South Texas Project Electric Generating Station 4000 Avenue F – Suite A Bay City, Texas 77414

February 10, 2010
U7-C-STP-NRC-100036

South Texas Project
Units 3 and 4
Docket Nos. 52-012 and 52-013
Response to Request for Additional Information

Attached are the responses to the NRC staff questions included in Request for Additional Information (RAI) letter numbers 299 and 302 related to Combined License Application (COLA) Part 2, Tier 2, Sections 3.7.1, 3.7.2 and 3.8.4.

Figure 03.08.04-17a: DCD total at-rest lateral soil pressure excluding SSE increment, H, for design of RB walls

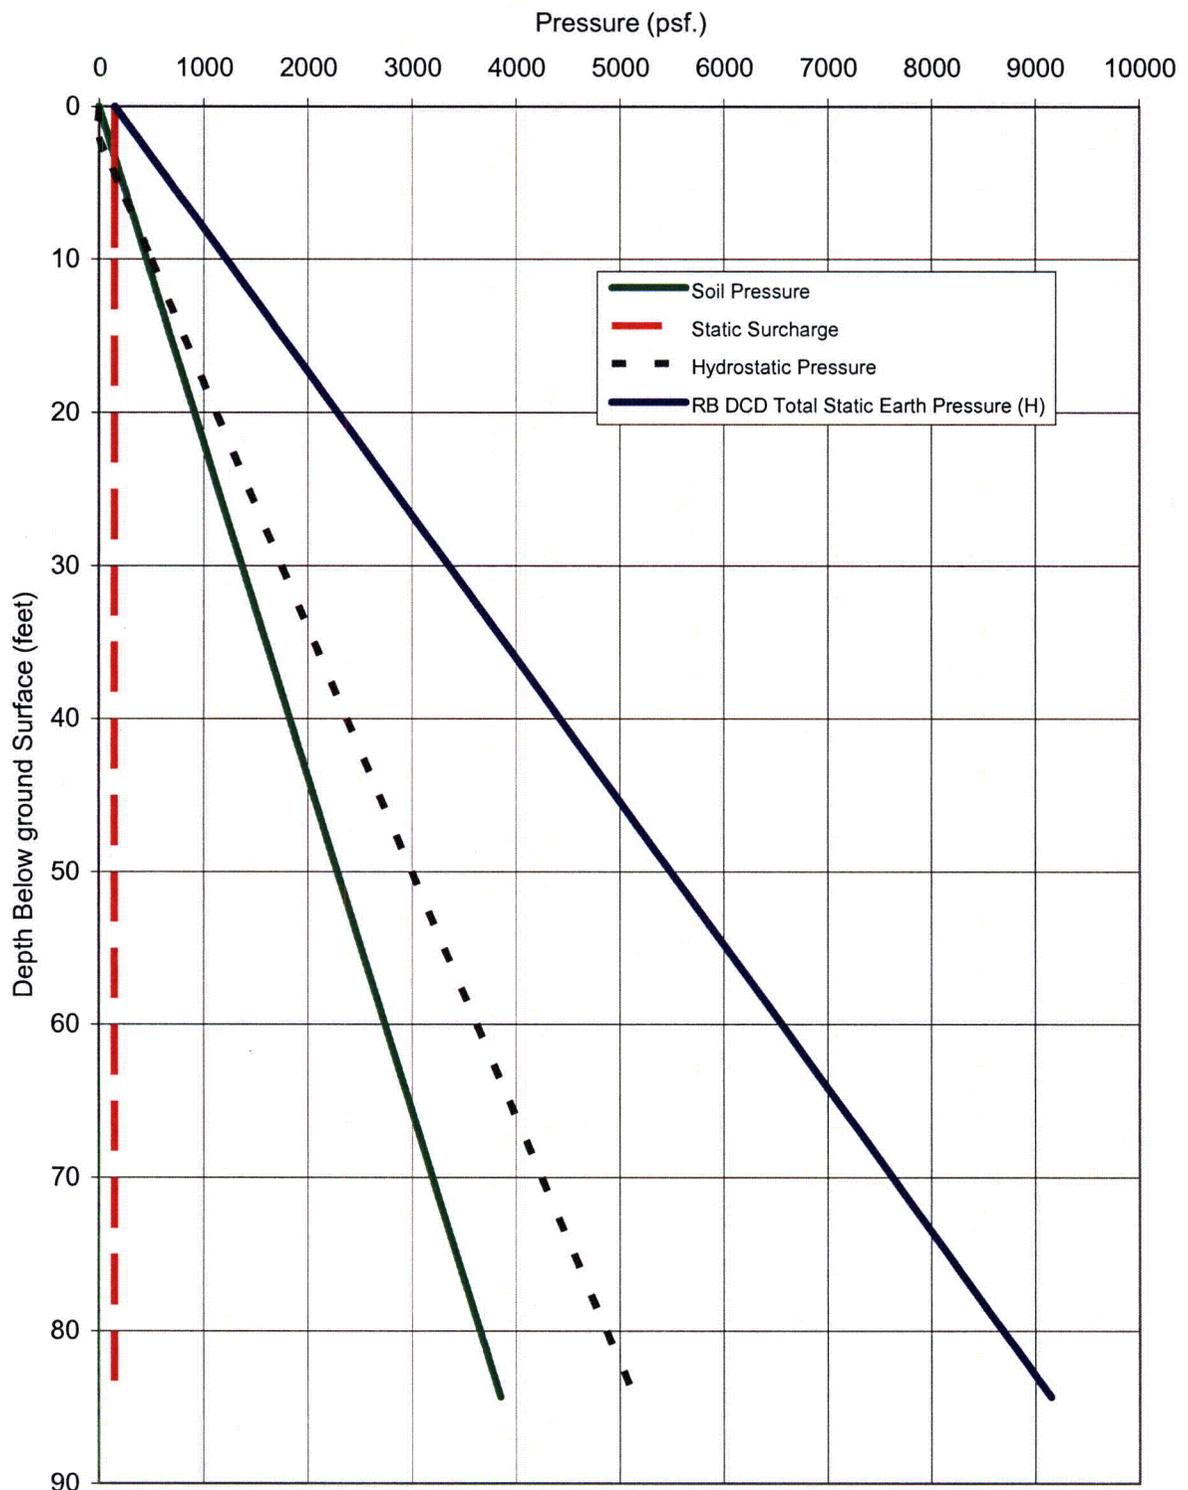
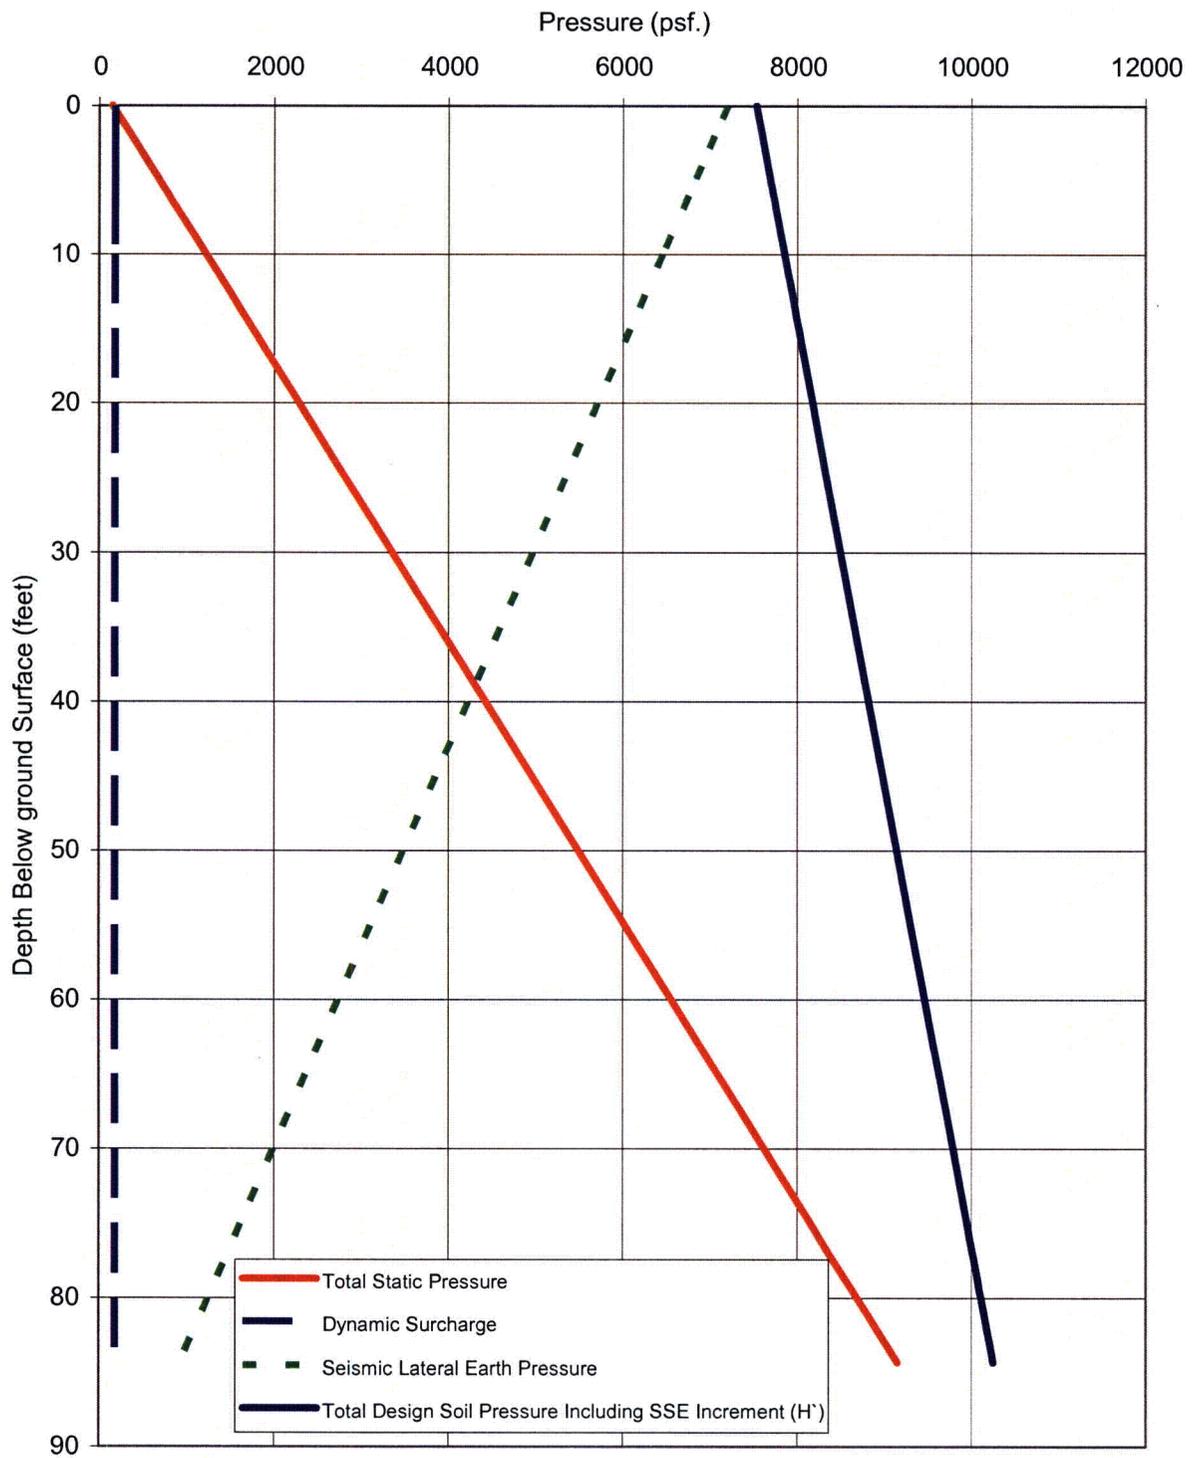
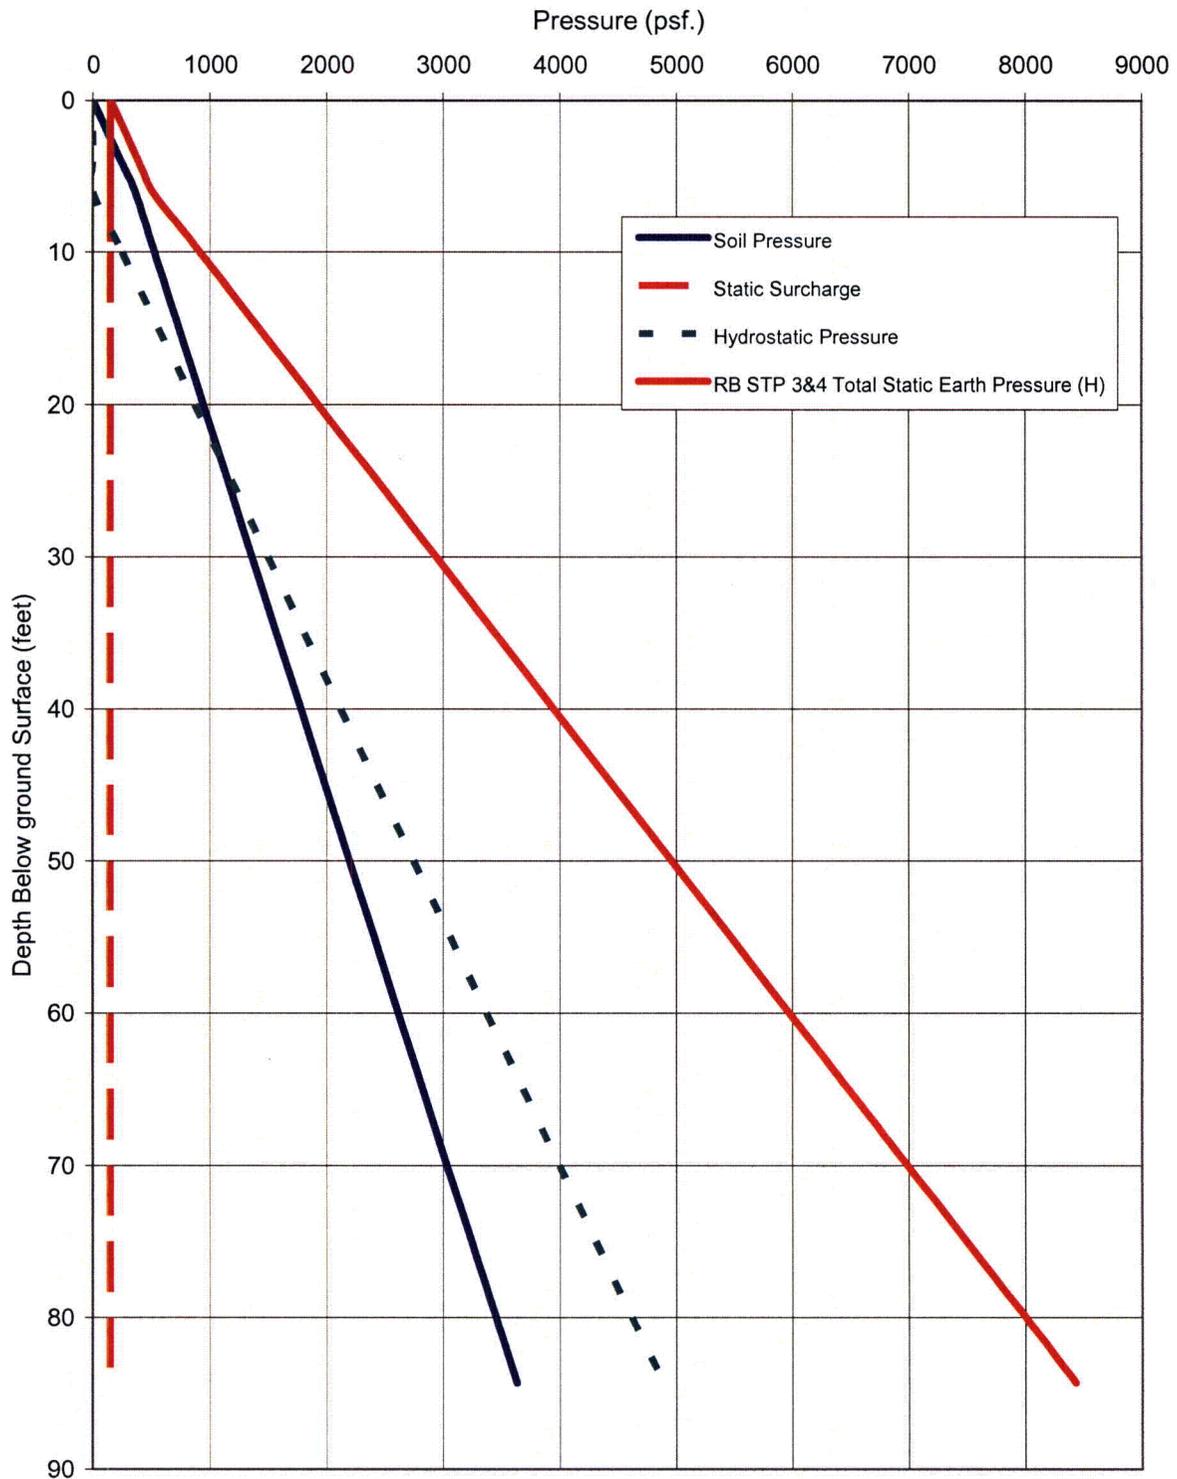
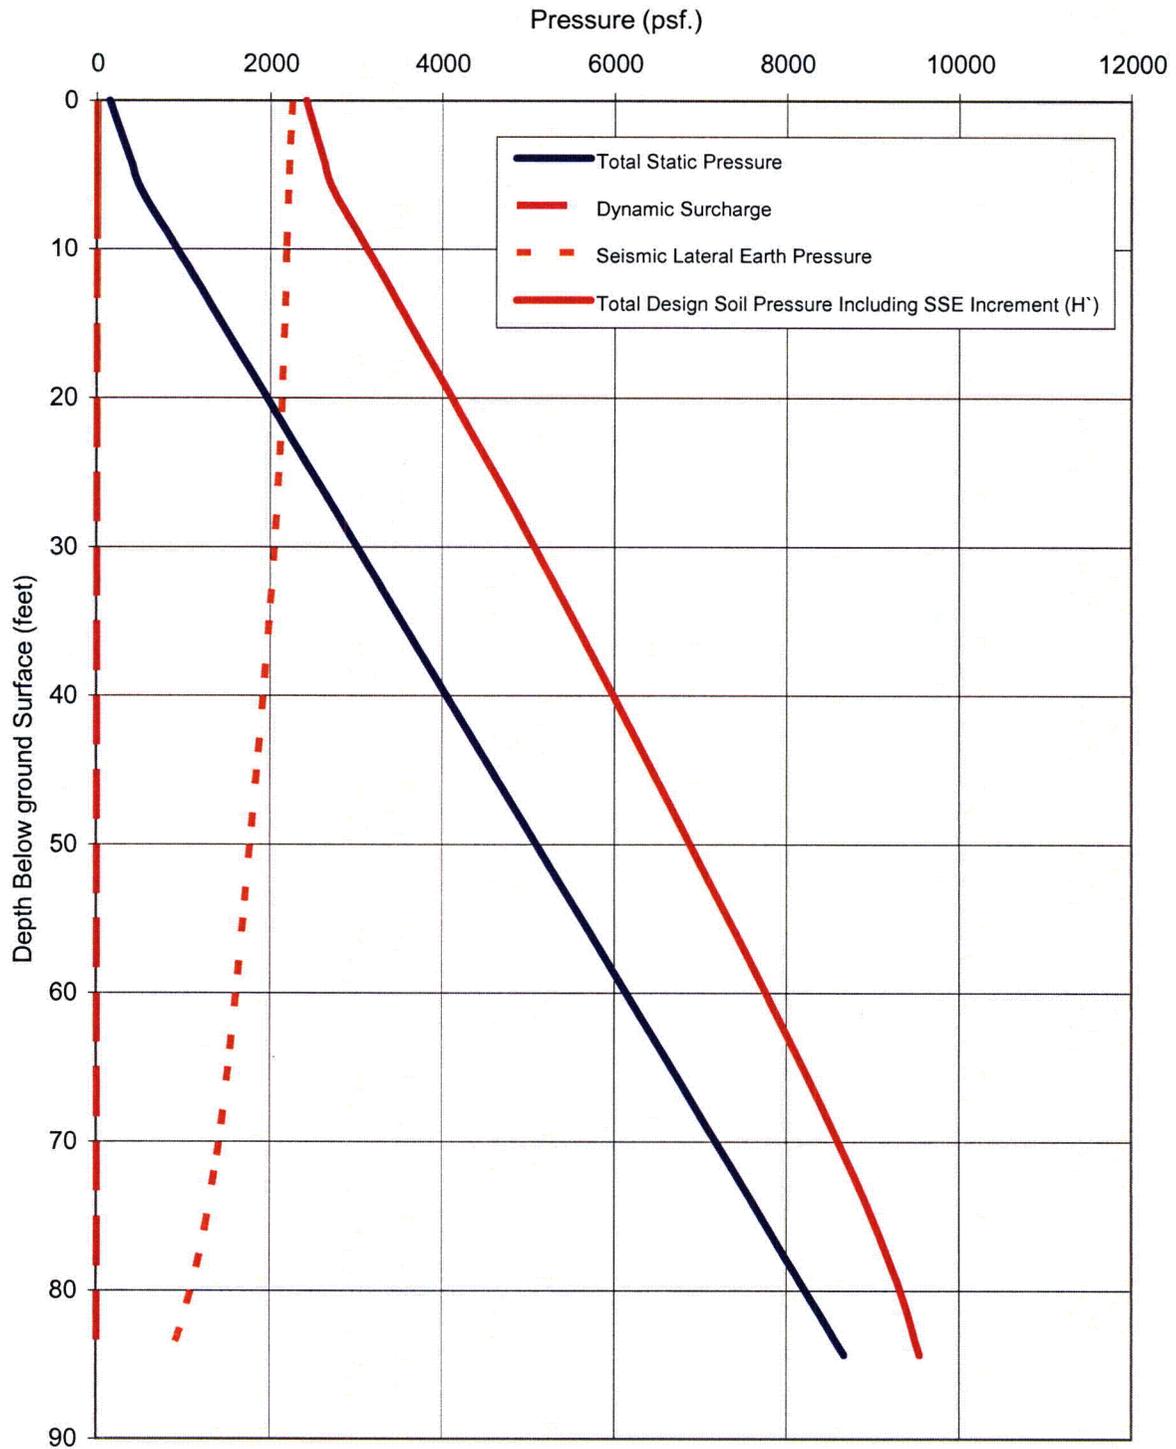
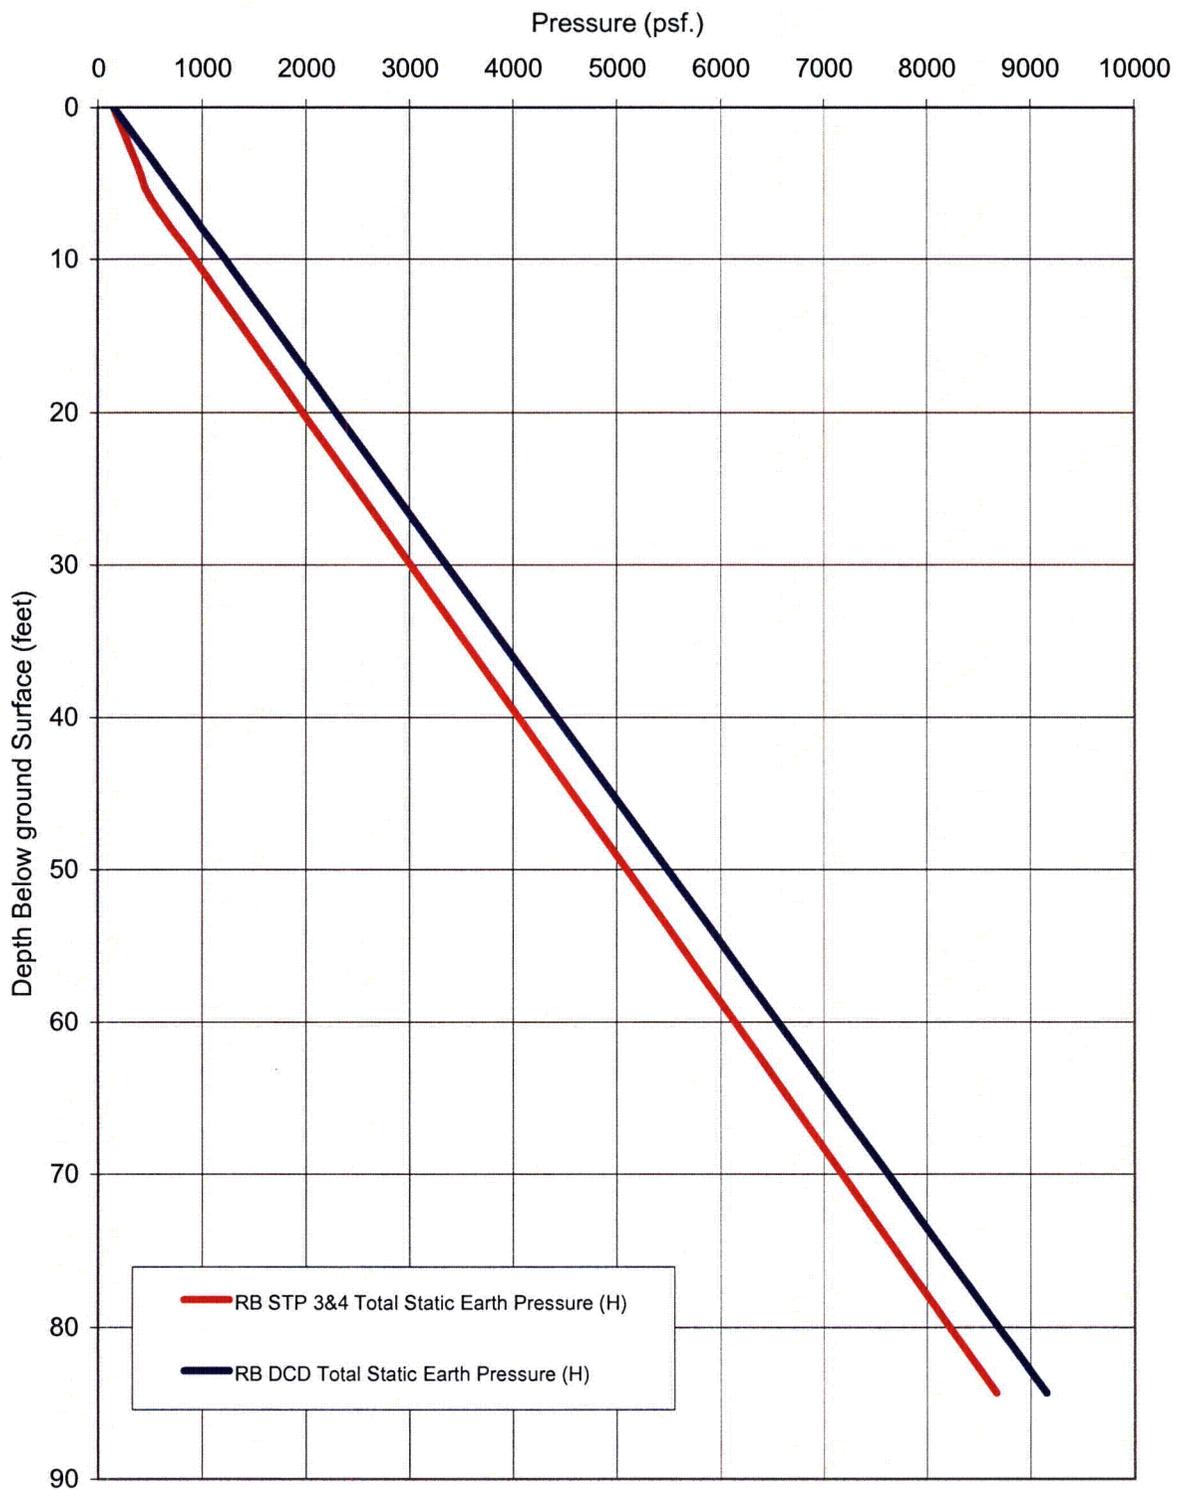
- b) Per Sections 3H.1.4.3.1.8 and 3H.1.5.5.3.1 of the ABWR DCD, Tier 2, the lateral soil pressures used for the design of Reactor Building (RB) walls are provided in Figure 3H.1-11 of DCD Tier 2. Also, per Section 3H.2.4.3.1.4 of DCD Tier 2, the lateral soil pressures used for the design of Control Building (CB) walls are provided in Figure 3H.2-14 of DCD Tier 2.

Figures 03.08.04-17a through 03.08.04-17l on the following pages provide the following:
